Kirkland NE 85th St Station Area Plan and Planned Action

Final Supplemental Environmental Impact Statement
December 2021

Subject: Final Supplemental Environmental Impact Statement (FSEIS) for the Kirkland NE 85th St Station Area Plan, Form-Based Code, and Planned Action

Exhibit 1-7. Alternative 2 Land Use Change Areas

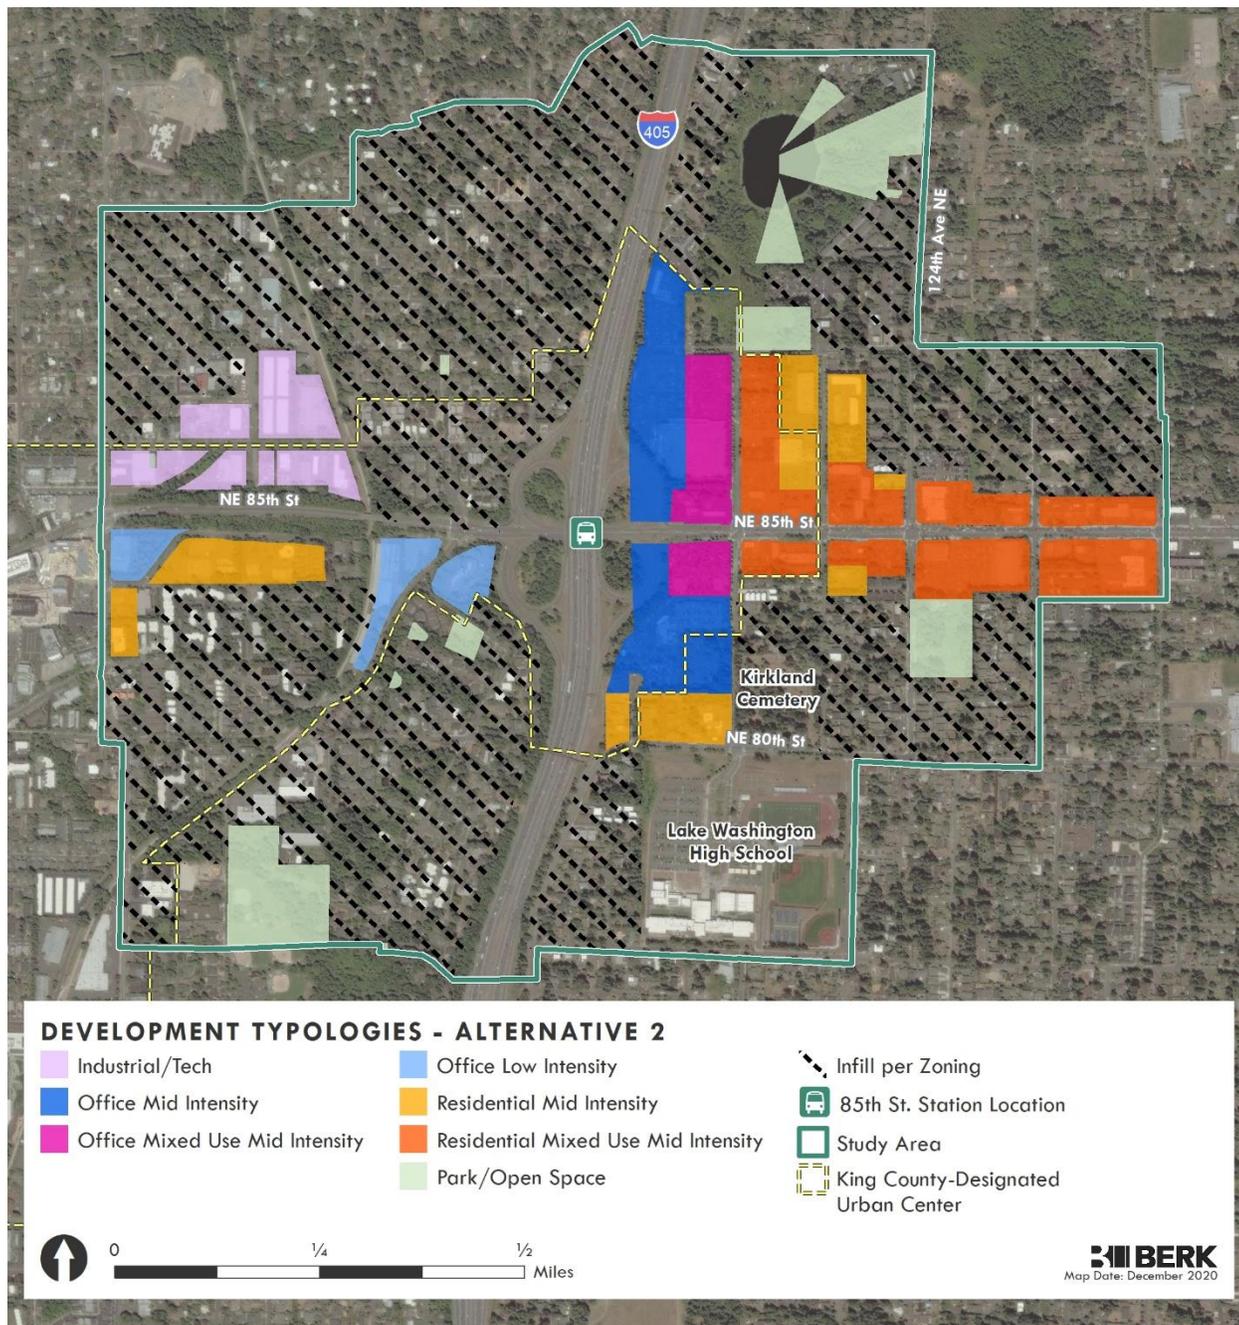
9. Page 1-10, Section 1.4, "Land Use Patterns and Building Height"
The "Industrial/Tech" and "Office Mid Intensity" areas in Exhibit 1-7 are too far from the station for pedestrian access and the access streets are too narrow for effective/efficient transit access. Thus this new use of these areas will require auto access for workers and the plan does not accommodate this traffic or parking requirement increase.

Number	Commenter and Summary	Response
	accommodate expected auto traffic.	
73-9	Industrial/Tech and Office Mid Intensity areas in Exhibit 1-7 are inaccessible by walking or transit, and plan does not accommodate expected auto traffic.	See multimodal investments proposed with each alternative in DSEIS and FSEIS Section 3.6 Transportation.
73-10	Plan does not address costs of anticipated school facility construction or associated traffic impacts.	Costs are not a required SEPA topic (WAC 197-11-448 and 450). However, a fiscal analysis was conducted to review the feasibility of investing in infrastructure and services. See Appendix B.
73-11	Disagreement with proposal to increase capacity of Lake Washington High School by adding one or two stories.	The comments are noted and forwarded to City decision makers. Height changes were included in Alternatives 2 and 3. FSEIS Alternative B, the preferred direction includes a height increase for the LWHS site. Increasing building height on current school sites may be most cost-effective way to increase school capacity, due to escalated land costs in Kirkland and nearby communities.

Exhibit 1-8. Alternative 2 Building Heights

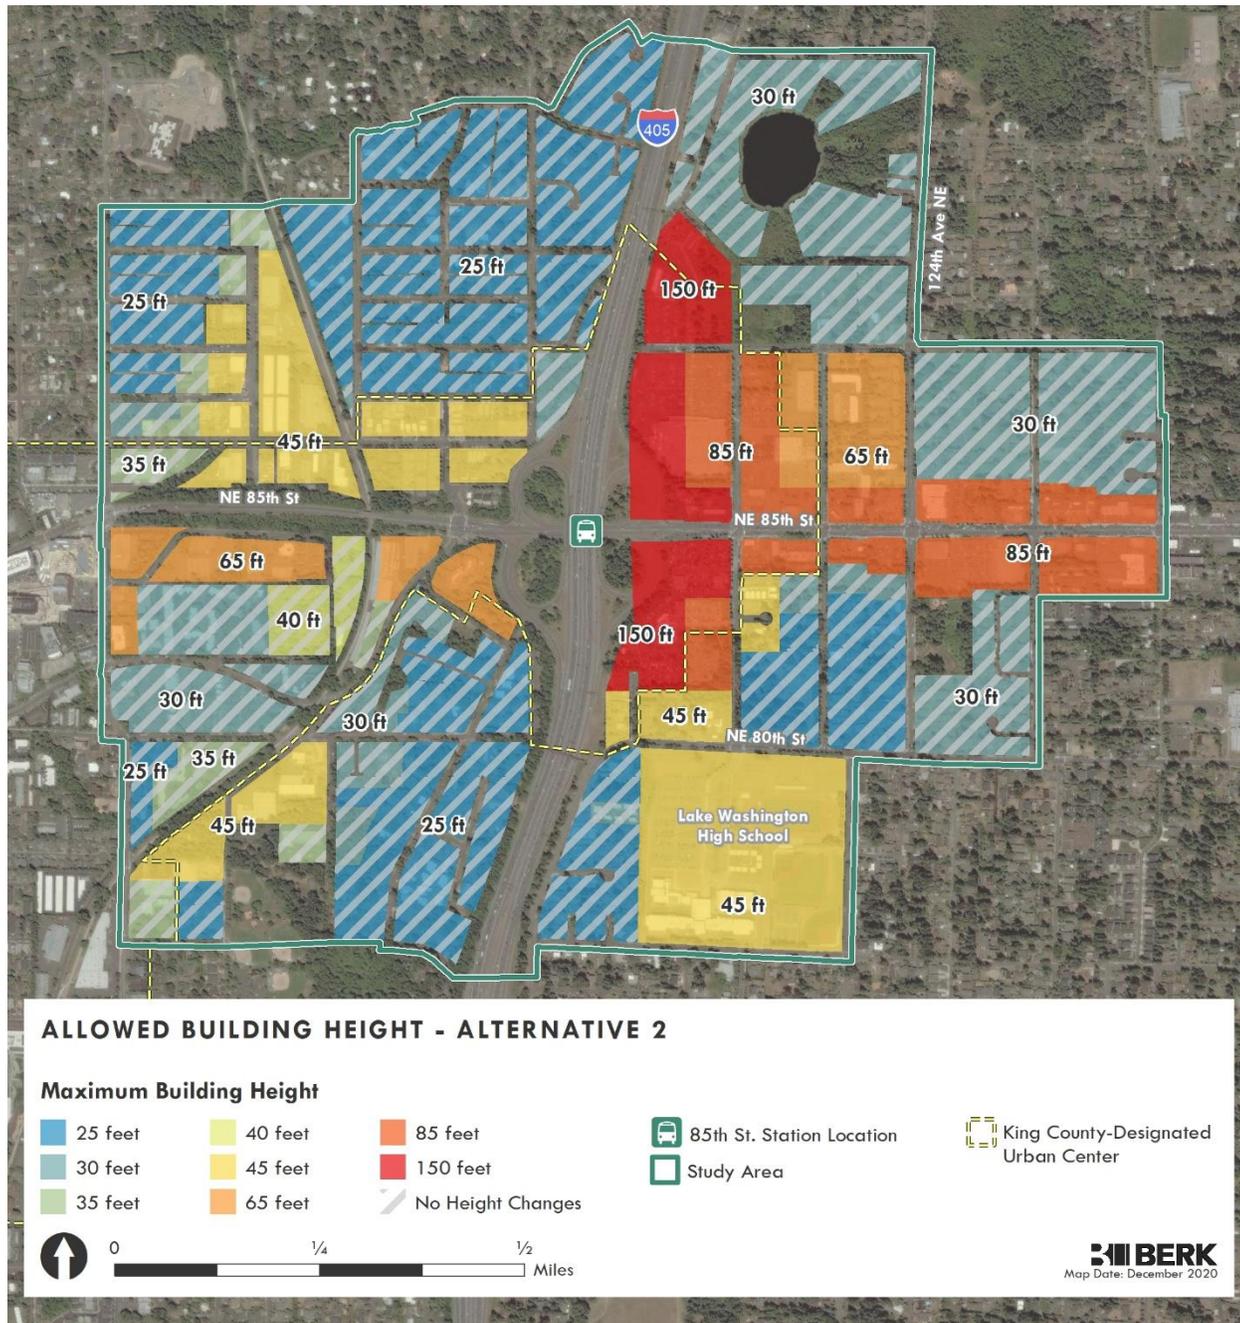
10. Page 1-10, Section 1.4, "Land Use Patterns and Building Height"
The note at the bottom of the page: "...the alternative considers adding a story in height at the Lake Washington High School. See Exhibit 1-8." is naive. First, the plan does not include the cost of expanding the school. Second, this would require replacement of a new and several newer buildings that are well within their service life at a cost that is not contemplated by the plan. Third, a school campus is a system and adding more classroom space also requires supporting auxiliary facilities, the cost of which is not part of this plan. Forth, adding so many students to a school increases congestion in the entire area and the impact of this added congestion is not discussed in the plan.

Exhibit 1-15. Alternative B: Transit Connected Growth- Heights

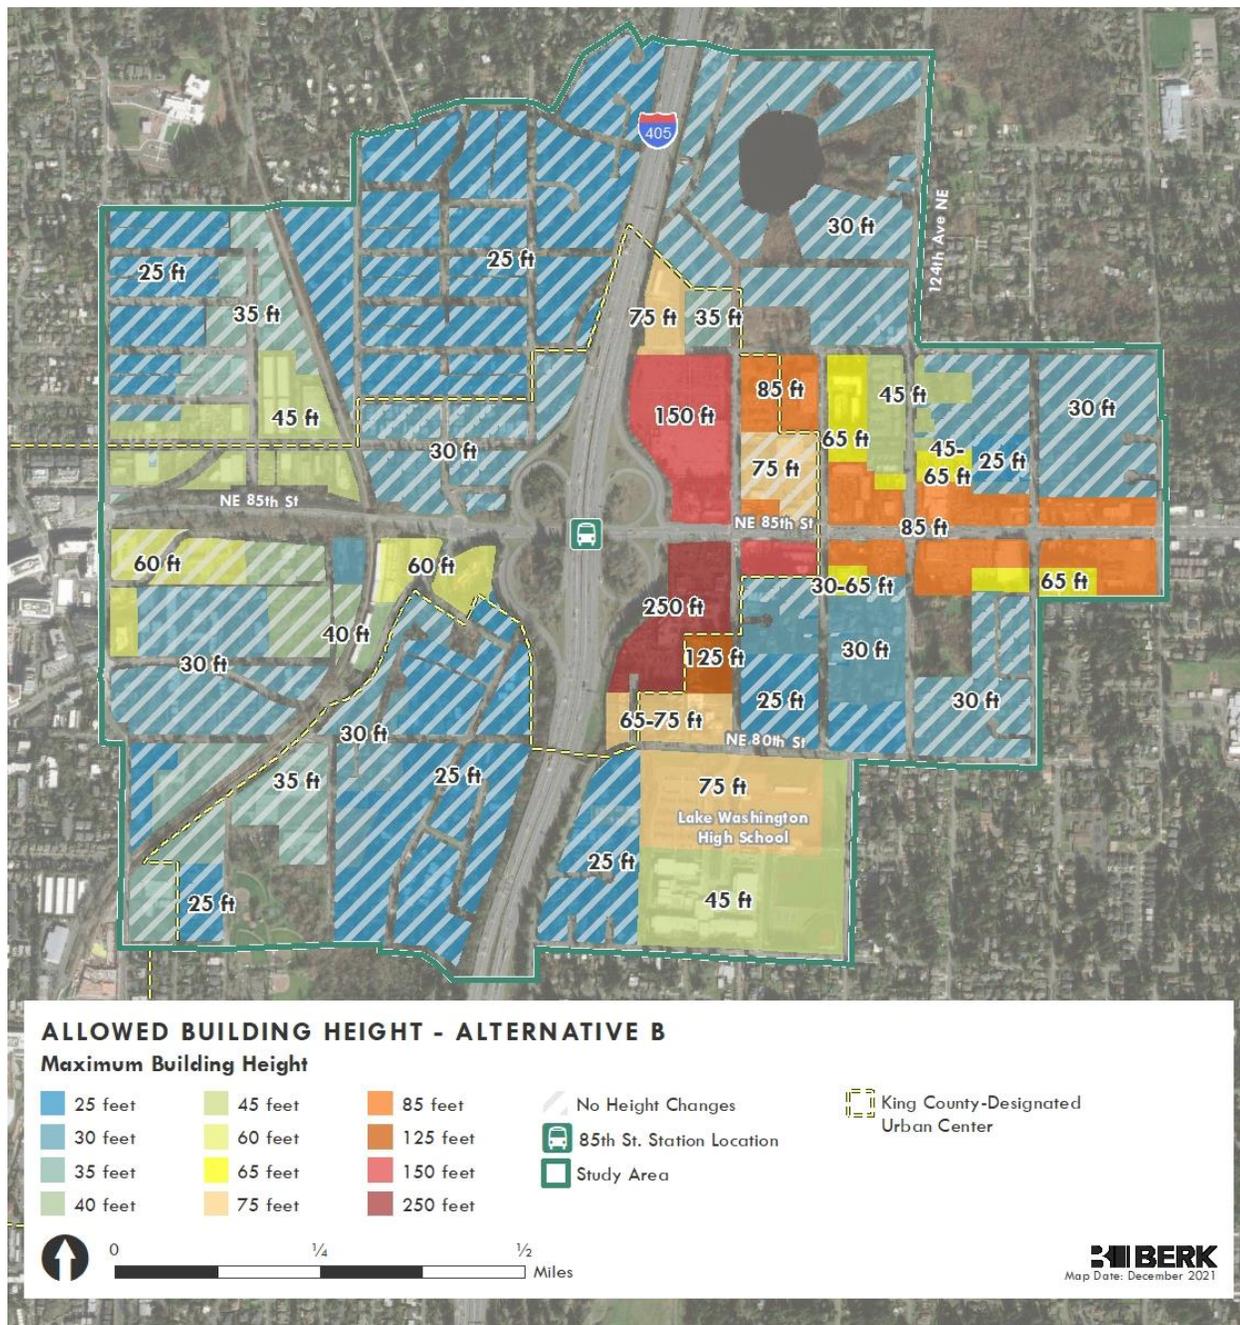
16. Page 1-20, Section 1.4, Exhibit 1-15
The assertion: "Parking: As the Study Area will benefit from proximity to planned high capacity transit and regional bike trail access, there may be a lessened need for onsite parking." The use of the term "may" is the tip off that this assertion has no value and should be removed. It's just window dressing.

17. Page 1-20, Section 1.4, Exhibit 1-15
The prayer: "District parking facility (Alternative 3 only): A district parking facility is conceptually located within Rose Hill commercial area that provides shared access to parking for commercial area users, visitors and residents in mixed use areas but would not be available for commuters." is absurd. What does it mean for a facility to be "conceptually located"? It's either in the plan or not. Since it's not, this should simply be deleted.

73-15	Section 1.4 Exhibit 1-15 does not provide detail or explain benefits and costs.	See response to comment 73-10.
73-16	Delete clause about lessened need for onsite parking in Exhibit 1-15.	The description is accurate that with greater transit there could be a lesser need for parking. However, parking standards would reflect the demand for each use.
73-17	Delete Alt 3 district parking facility.	The preference for excluding a district parking facility is noted and forwarded to City decision makers. FSEIS Alternative B, the preferred concept, does not include such a facility.

Exhibit 2-7. Growth Concept

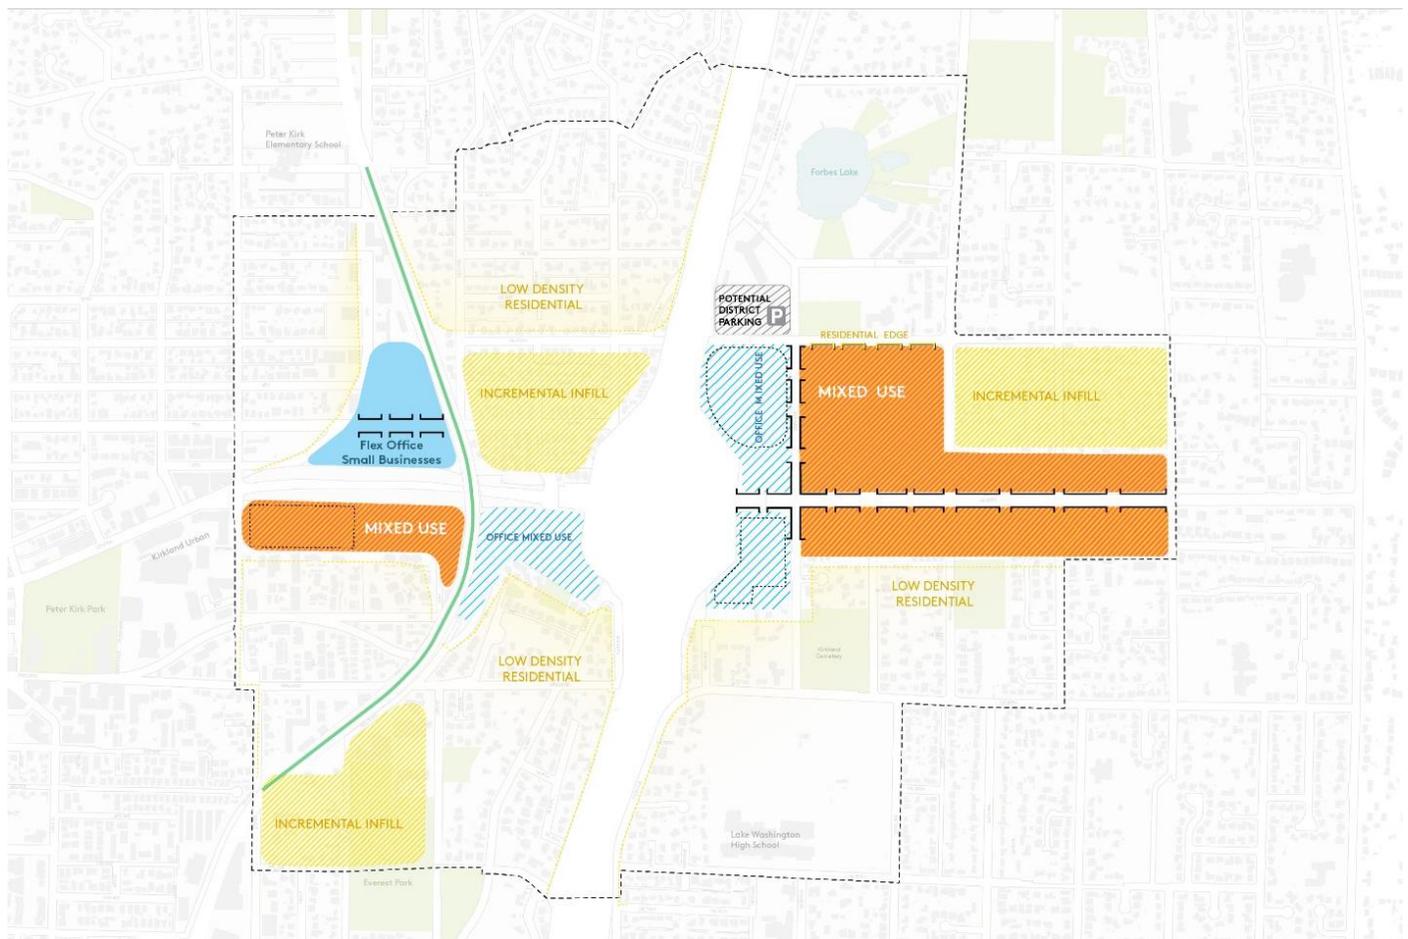
2) Exhibit 2.7 (Growth Concept) in the planning doc is very concerning since it indicates "Incremental Infill" that looks like it will occupy the northern half of Everest Park. It seems that other Exhibits preserve the entirety of Everest Park and its perimeter. We oppose any planning/measures that intend to replace some or much of Everest Park with "Incremental Infill". We should not further reduce greenery in the Kirkland community and Everest Park is well-loved and well-used by our surrounding neighborhoods.

1) Exhibit 2.7 (Growth Concept) in the planning doc is very concerning since it indicates "Incremental Infill" that looks like it will occupy the northern half of Everest Park. It seems that other Exhibits preserve the entirety of Everest Park and its perimeter. We oppose any planning/measures that intend to replace some or much of Everest Park with "Incremental Infill". We should not further reduce greenery in the Kirkland community and Everest Park is well-loved and well-used by our surrounding neighborhoods.

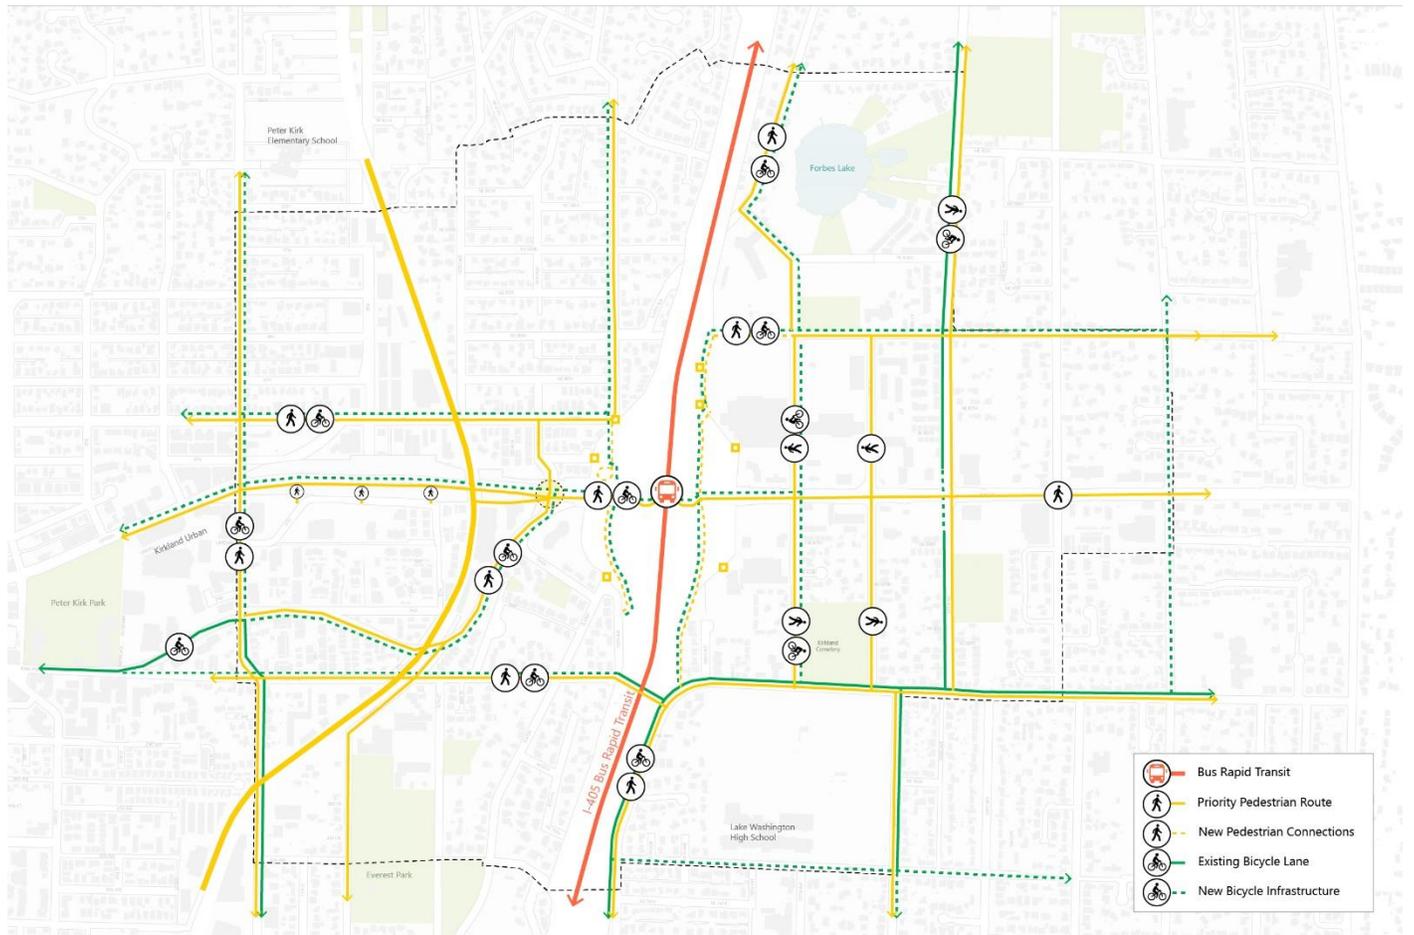
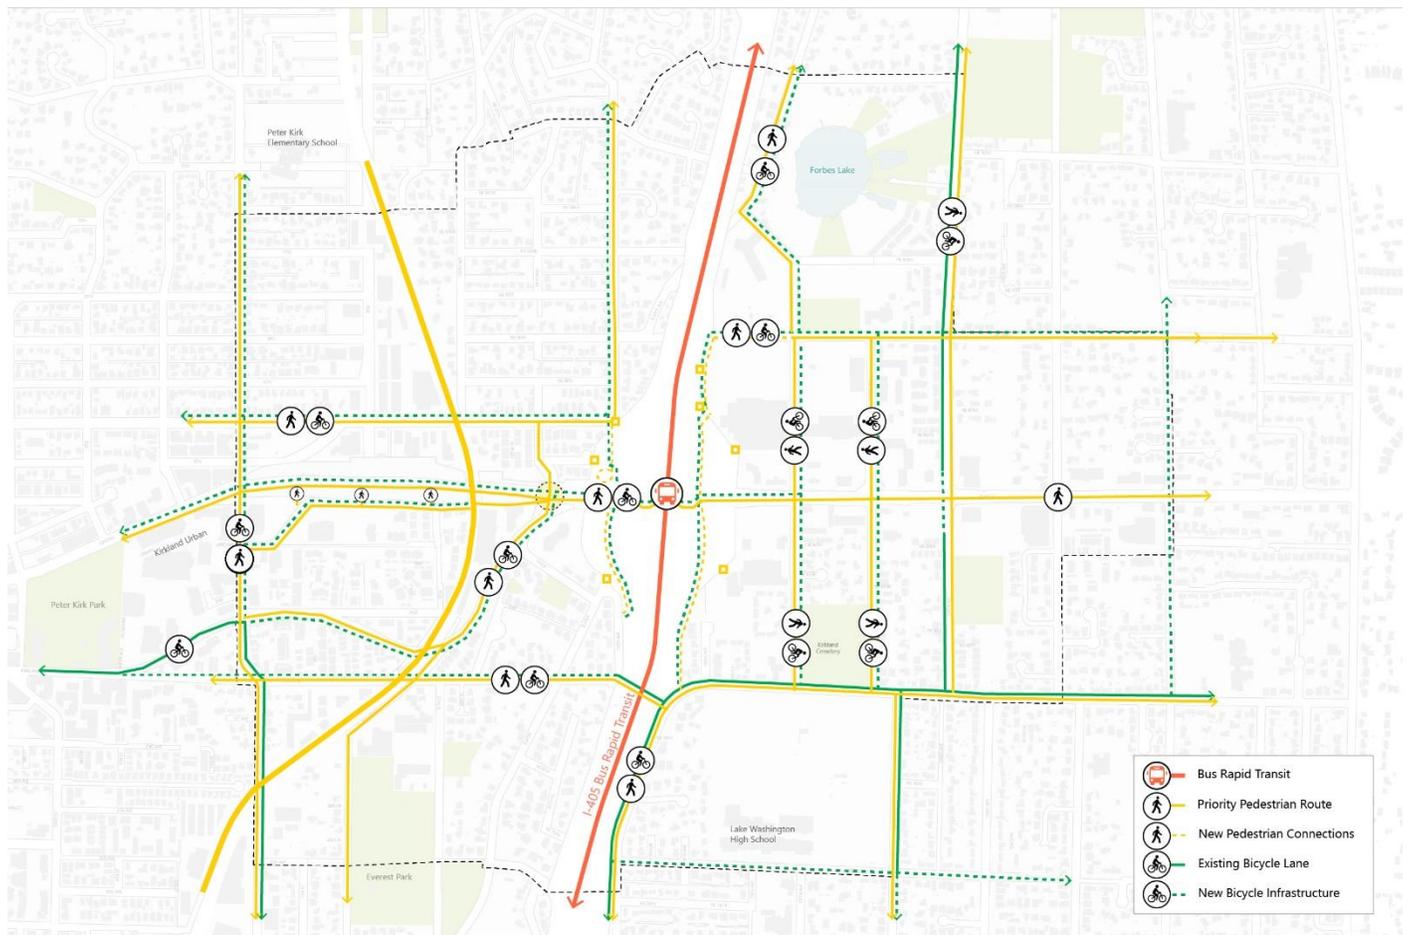
Legend symbols in the following three maps were reversed in the DSEIS for pedestrian and bicycle facilities. Alternative 2 and 3 DSEIS maps also incorrectly showed a new pedestrian connection and new bicycle infrastructure crossing I-5 at NE 90th St on (Exhibit 3-66 and Exhibit 3-67, respectively).
